#### 94 Moisture accumulation in headlamps

94 12 68 2028277/2 March 1, 2012. Supersedes Technical Service Bulletin Group 94 number 11 – 62 dated December 20, 2011 for reasons listed below.

Model(s)	Year	VIN Range	Vehicle-Specific Equipment	
	2010	All	Not Applicable	
Audi Q7	2011	All		
	2012	000001 – 021250

Figure 2. Ventilation Hose with Integrated Filter

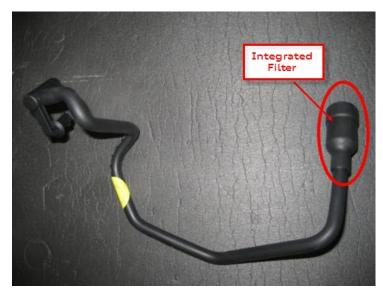
- 1. Remove the headlamps and dry the inside using compressed air or hot air blower.
- Replace the headlamp ventilation hose for each headlamp with the new part number to help reduce any further humidity ingress into the headlamps (see Part information table below).
   The modified ventilation hose can be recognized by the integrated filter as seen in Figure 2.

Part Number	Part Description	Quantity
4L0 941 717 A	Left Headlamp Ventilation Hose	1
4L0 941 718 A	Right Headlamp Ventilation Hose	1
